**Project #20-005
L59 Redesign
Located at approximately 150 S. 100 E.**

Project Name: L59 Redesign
Proponent / Owner: Beth Larchar / DC1 Logan LLC (Trent Cragun)
Project Address: 150 S. 100 E.
Request: Design Review Permit & Rezone
Current Zoning: TC1, REC & NR6
Type of Action: Quasi-Judicial & Legislative
Hearing Date Jan. 23, 2020
Submitted By: Russ Holley, Senior Planner

DATE: Feb. 27, 2020
FROM: Russ Holley, Senior Planner
SUBJECT: **L59 Site Plan and Alternative Parking Plan**

Alternative Parking Plan

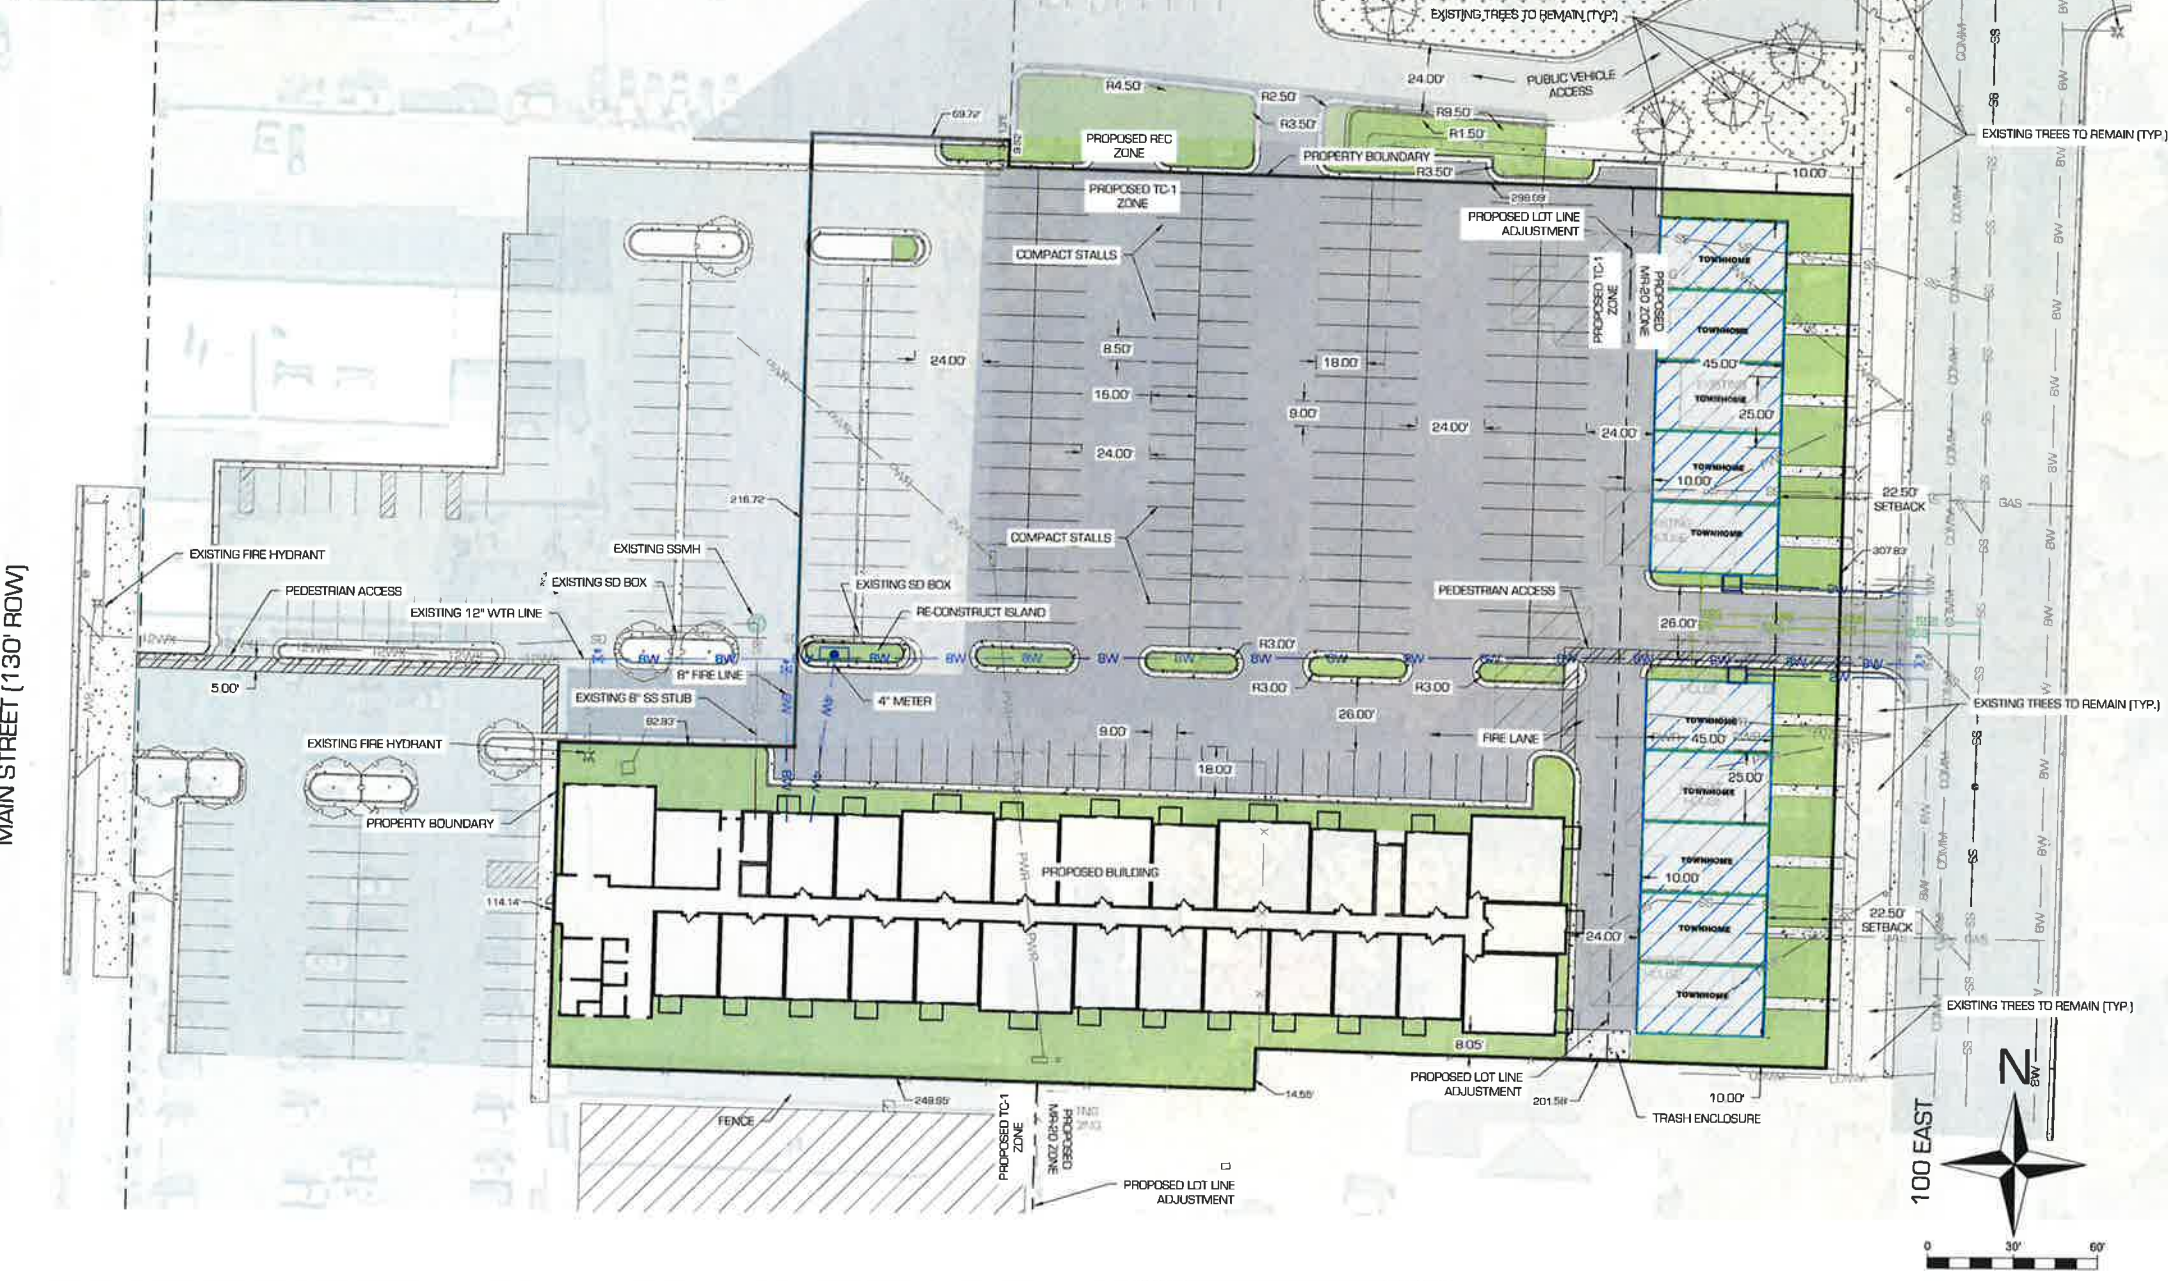
Summary:

194 required

183 onsite and available 24 hrs/day

This is less than a 1% parking variance request.

Here are the reasons I see the variance as a reasonable request and why we believe the building has sufficient parking and to spare:

- **there are still 21 stalls available off site (albeit daytime only)**
- **there are 40 public stalls to the north next to Garff Gardens (we will NOT encourage or advertise these, but they are available in the case of an event that causes Chuck-a-rama to be busier than normal (like graduation))**

- **there are approximately 18 stalls of street parking on Main Street (again, in the event of a rare occasion that daytime parking is full)**
- **there is a bike lane on 100 East to make biking in the downtown area convenient for residents**

- **there is a CVTD bus stop within two blocks in every direction of this project**
- **Highmark's numbers show that in a project with a majority of 1-bedroom apartments, 2 spaces per unit is over-parked (this project has a much higher ratio of parking than their other projects, and their lots are not full)**

- **peak times at Chuck-a-rama and JoAnn's are nearly opposite of when residents are usually home (chuck-a-rama peak times are 12-8 PM and JoAnn's peak times are 10 am to 4 pm (according to Google))**

The on-site parking ratio for this project is 1.7
